Installation Instruction for Turn Handle Assembly and Single Point Lock Assembly

TO REPLACE OLD STYLE LOCKBOX with NEW STYLE for OLD SINGLE LEAF SCUTTLES with SINGLE POINT LOCKS

Installation Instruction for Turn Handle Assembly and Single Point Lock Assembly

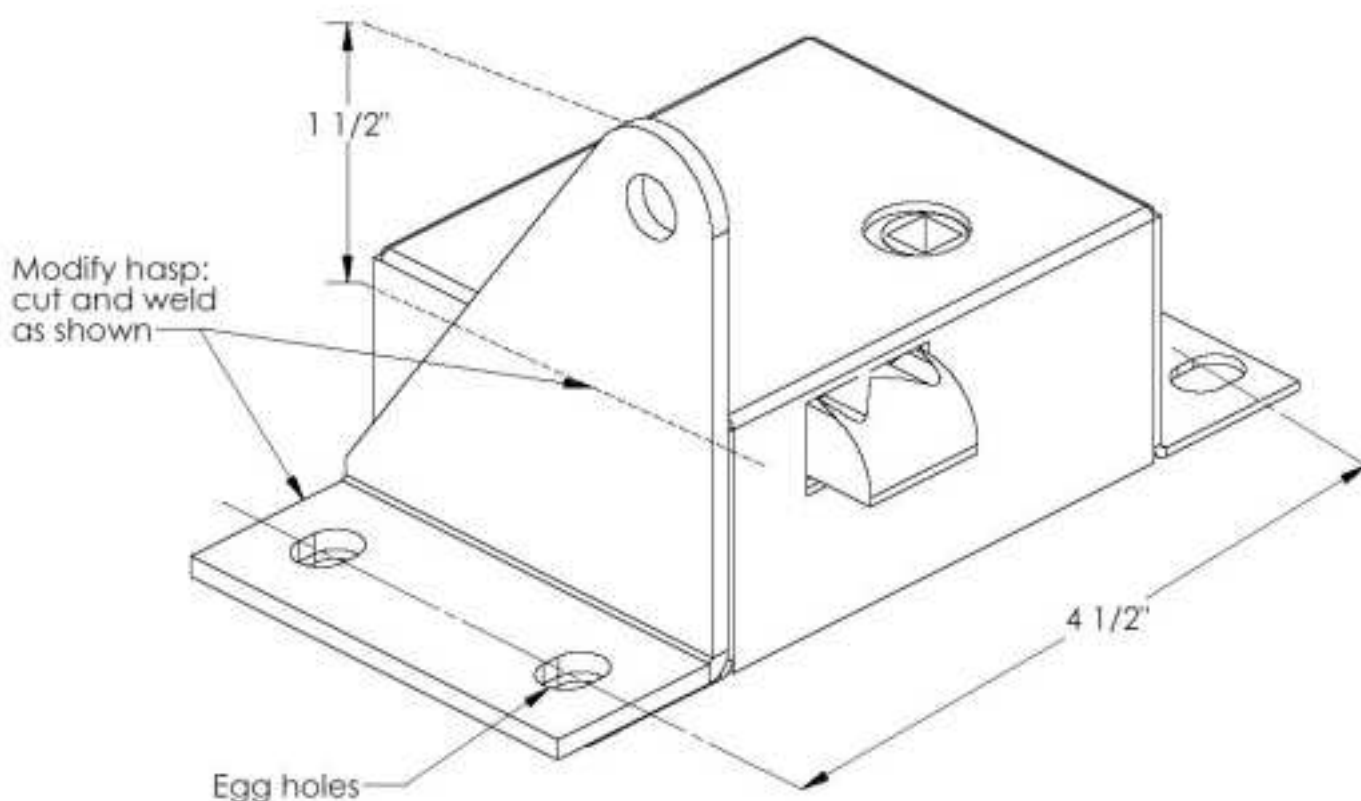
- 1) Egg out mounting holes in lock case to 4 1/2" O.C.

- 2) Have customer relocate strike (SD49B_) 3/8" lower on unit..

WE DO NOT PROVIDE OLD STYLE LOCK CASES ANYMORE!

Note lock assembly w/egged holes, strike, handle and hasp assembly, self-tap bolts and drill bit to relocate strike holes
